Report By:

National TAB
1329 E. KEMPER ROAD
SUITE 4210
CINCINNATI, OH 45246

Report: TAB Report
Function: Test, Adjust, & Balance
Date: 07/03/2024

06-24-24 WAWA #5413 SARASOTA, FL

IMG_0549
06/26/2024

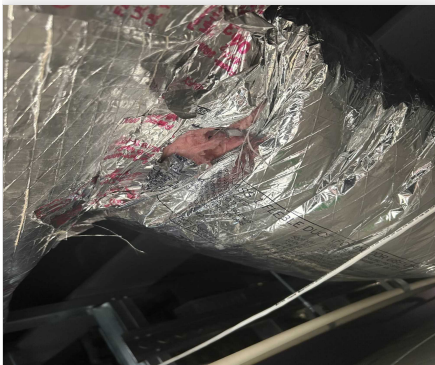
Issue Name : Diffuser 2-1 - damper missing wing nut
Description : Diffuser 2-1 currently has an airflow of 677 CFM (135% of design) and cannot be lowered because the damper will not hold the required position; it is missing a wing nut opposite the handle. Recommend repairing damper to allow for airflow adjustment.

- **06/30/2024 National TAB - Mark Johnson**
 - Mechanical clarified that damper design does not require second wing nut, and tightened handle to allow for adjustment. Could not re-adjust on site under time constraint.

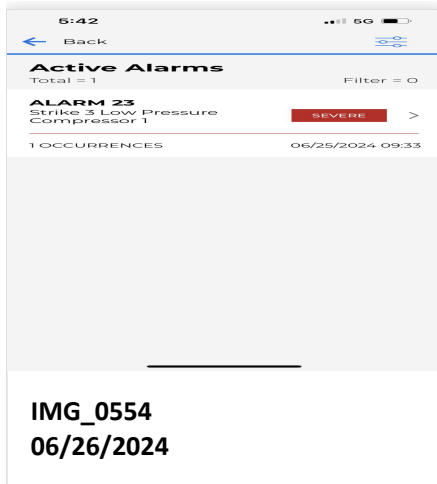
Issue Name : EF-2 low flow
Description : EF-2 is experiencing low exhaust flow (22 CFM, 37% of design) after installation of speed controller. Additionally, the fan is starting and stopping at frequent intervals. Fan is set to max speed. Recommend checking speed controller and wiring for possible faults.
